NOTICE OF DISPOSITION FOR A TENTATIVE SUBDIVISION PLAT

ORDER NO. 2016-053

CASE: ELLE'S ADDITION (SUB16-00002)

H1
 # 1 OF 1 SHEETS

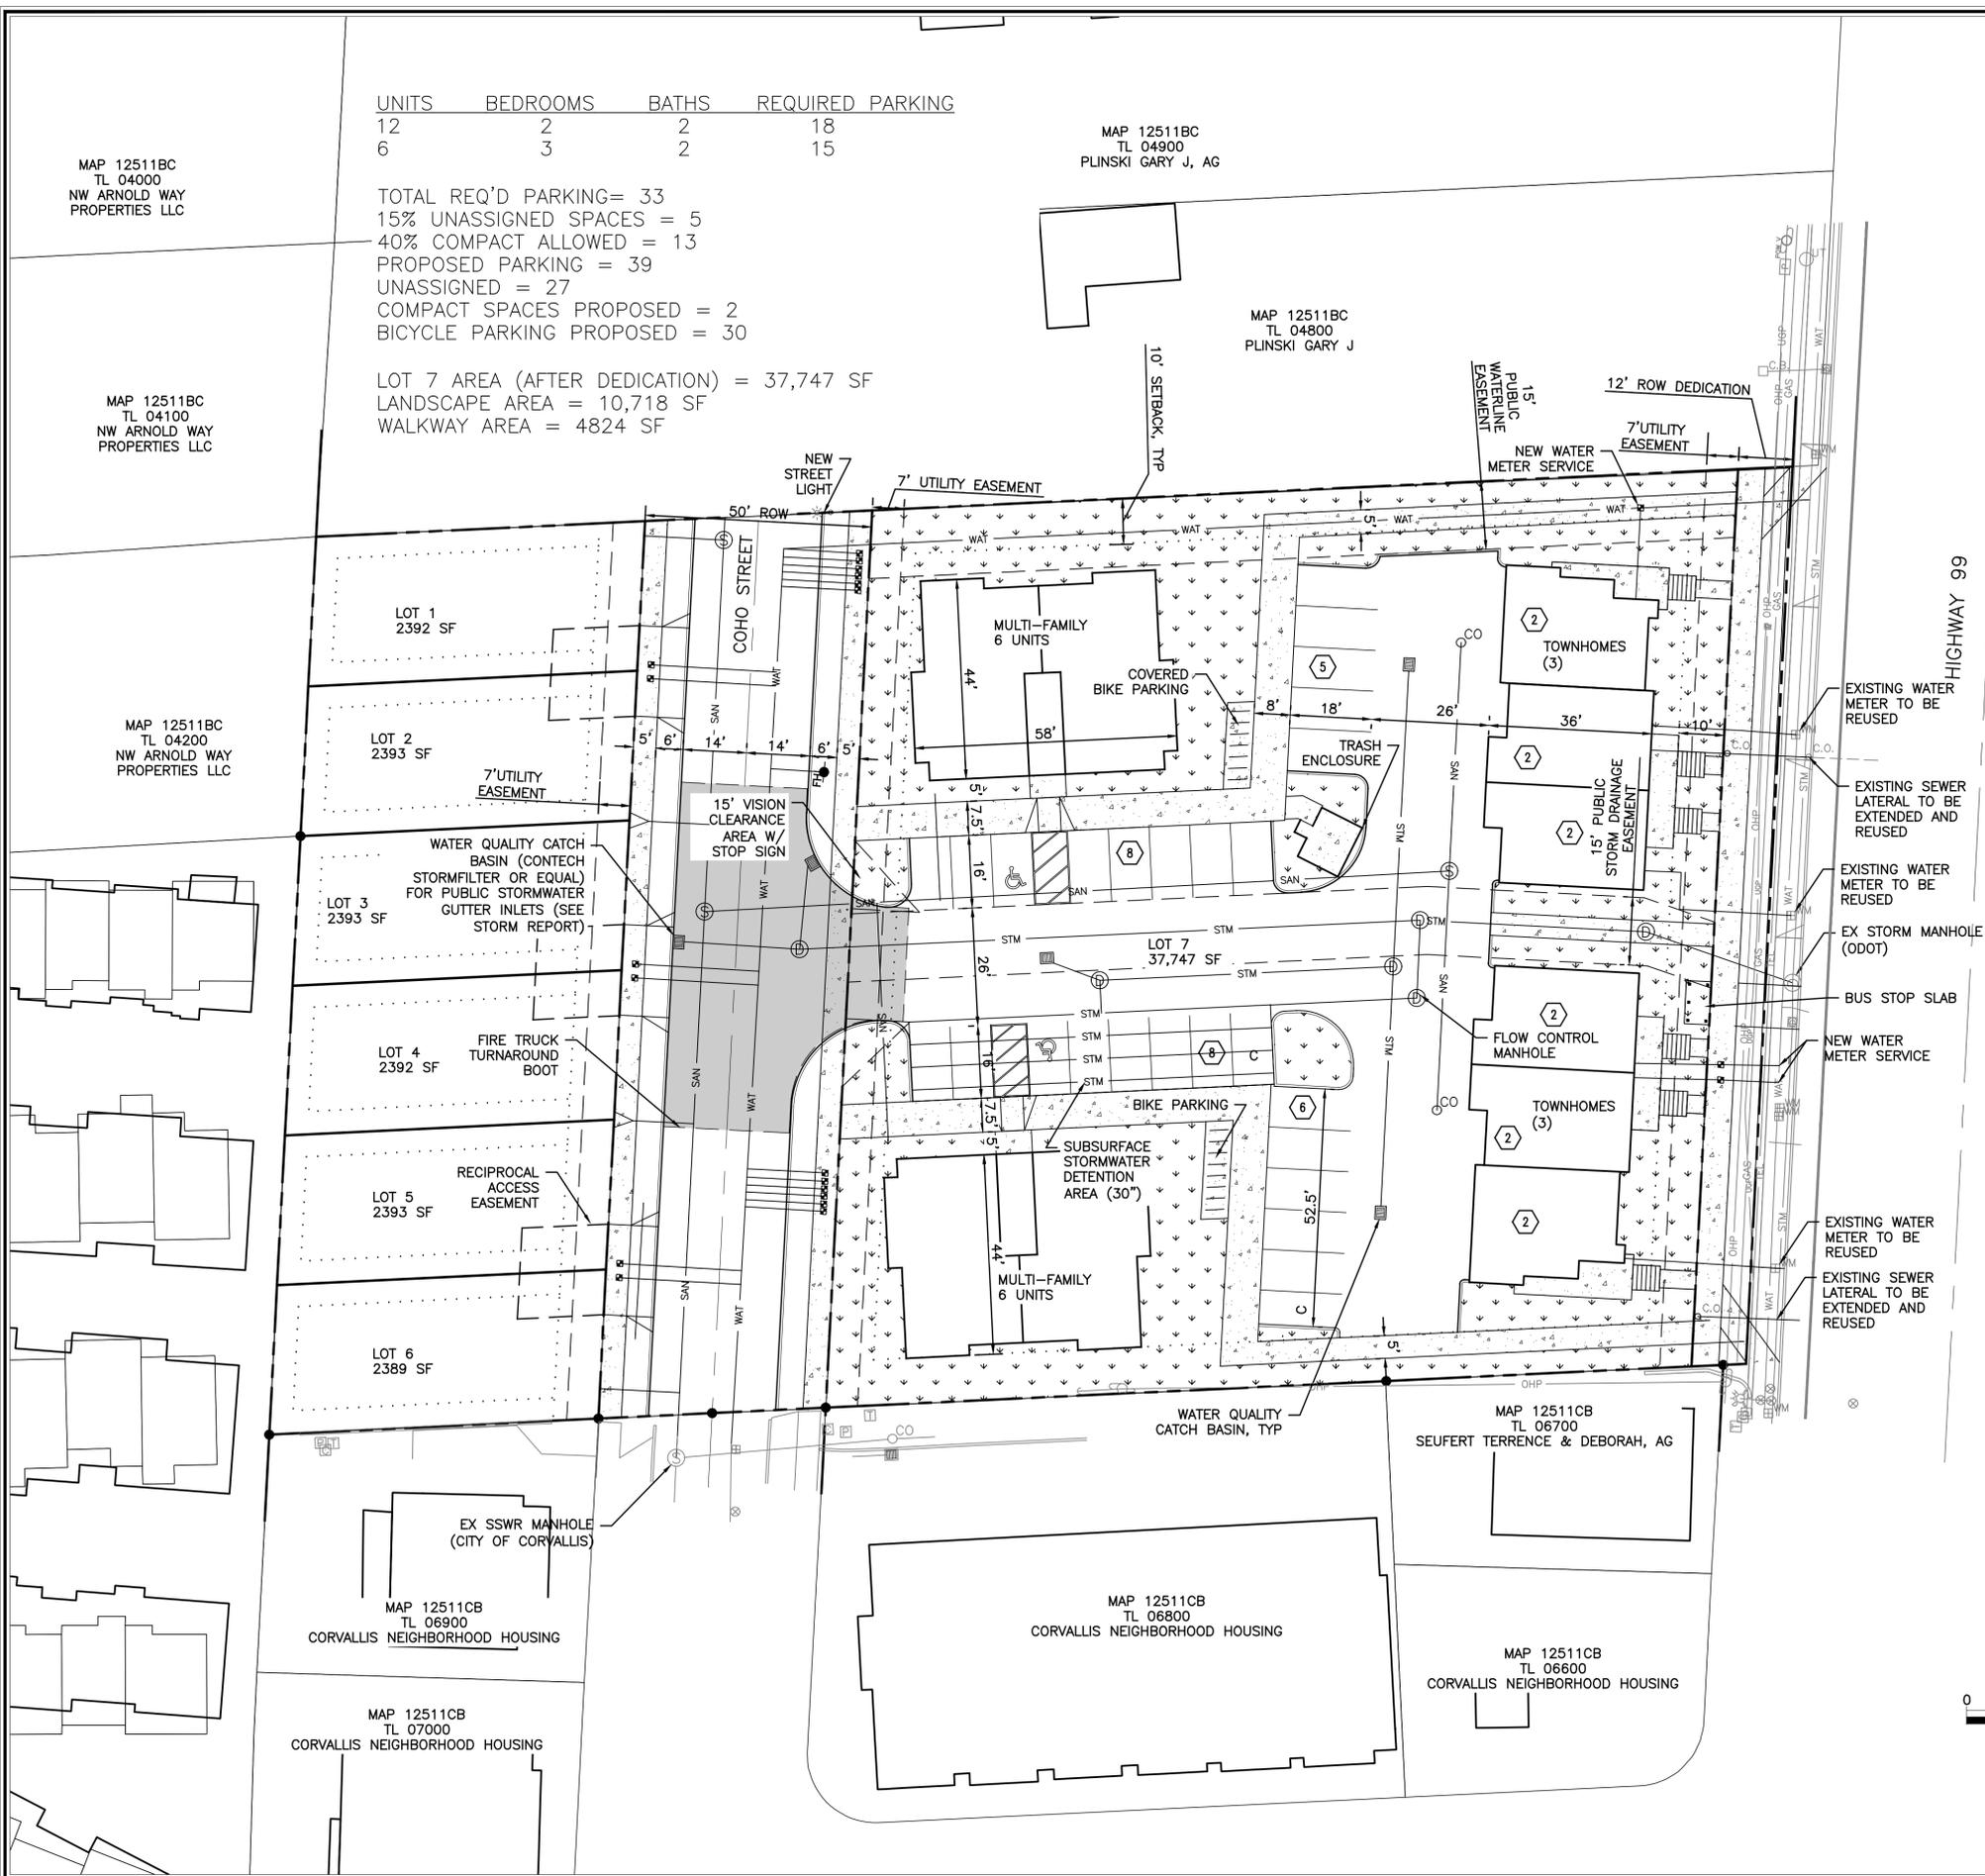
Coho Street and the west side of SW 3rd Street. The proposal includes 170 feet of street frontage along the east side of SW Coho Street. The applicant proposes six medium-canopy trees along both the east and west sides of SW Coho Street and eight medium-canopy trees along the west side of SW 3rd Street. Staff finds that the proposed tree plantings along the east side of SW Coho Street and the west side of SW 3rd Street comply with Table 4.2-1. Staff finds that the proposal requires one additional tree along the west side of SW Coho and that the applicant's narrative states that the applicant is willing to accept a condition of approval requiring one additional tree in this location. Staff finds that the applicant shall be required to plant one additional tree on the west side of SW Coho Street per Table 4.2-1. The additional tree may be planted in the lot area within one of the six single-family lots and shall be illustrated on the required landscape plans (**Condition 24**).

The Conceptual Landscape Plan shows a few trees that are located less than 10-feet from public utility lines. Per LDC 4.2.30.b.2.d, trees cannot be planted within 10-feet of public utility lines (**Condition 25**).

20	24	<p><u>Additional Tree Installation</u> – The applicant shall revise the landscape plan to include one additional tree on the west side of SW Coho Street to comply with Table 4.2-1. The additional tree may be planted in the lot area within one of the six single-family lots. The additional tree shall be planted prior to issuance of a certificate of occupancy for the subject single-family lot.</p>

Pg# Ref	Cond #	CONDITION
20	25	<u>Trees and Utilities</u> – Per LDC 4.2.30.b.2.d, trees shall not be planted within 10-feet of public utility lines. The proposed Conceptual Landscape Plan will need to be modified to meet this requirement.
